## Addendum No. 5 To IMPACTED MATERIALS PLACEMENT PLAN **ON-SITE DISPOSAL FACILITY**

**Alternate Placement Requirements Category 3** (Transite Panels)

> 20100-PL-007 Revision € D November 1999 June 2000

### Addendum No. 5 to Impacted Material Placement Plan **On-Site Disposal Facility** Alternate Placement Requirements for Category 3 Material (Transite Panels)

FIGURE NO.	· 1
PROJECT NO.	GQ0573-11
DOCUMENT NO.	F9930116
FILE NO.	FIGS1.cdr

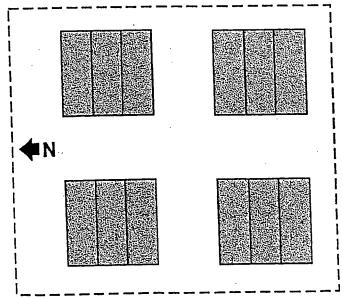
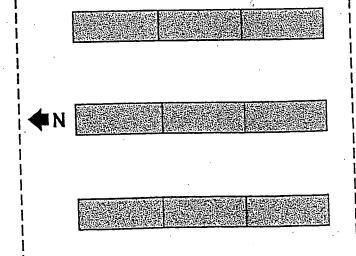
placed on the surface in the prescribed pattern iliustrated in Figure 1. Groups of bundles may be placed adjacent to existing 2-foot high berms constructed for Category 2 grids. Minimum spacing between groups of bundles shown on Figure 2 and 3 shall be 8 ft (2.4 m) to allow Category 1 material placement and compaction with suitable equipment. The space between groups of bundles shall be filled with Category 1 material placed in maximum 12 in (300 mm) thick compacted lifts. Lifts shall be brought up uniformly around the group of transite bundles. A final 12 in (300 mm) thick compacted lift of Category 1 material shall be placed over each grouping of bundles. Placement of Category 1 material is illustrated in Figures 2 and 3.

The alternate requirements for this method allow for placement of three bundles of packaged transite panels in a side by side configuration. The side by side configuration is shown in Figure 2. The transite bundles shall be oriented relative to north and south as shown in Figure 2. Bundles of the same size shall be grouped together whenever possible. Bundles can be stacked, such that their combined height is 4 ft (1.2 m) or less. When bundles of various dimensions are placed in a single group, their orientation shall be such that zones are not created which hamper the placement of Category 1 material. Examples of preferred groupings of different size bundles are shown in Figure 4.

The alternate requirements for this method allow for placement of three bundles of packaged transite panels in an end-to-end configuration. The end-to-end placement configuration is shown in Figure 3. Transite bundles shall be
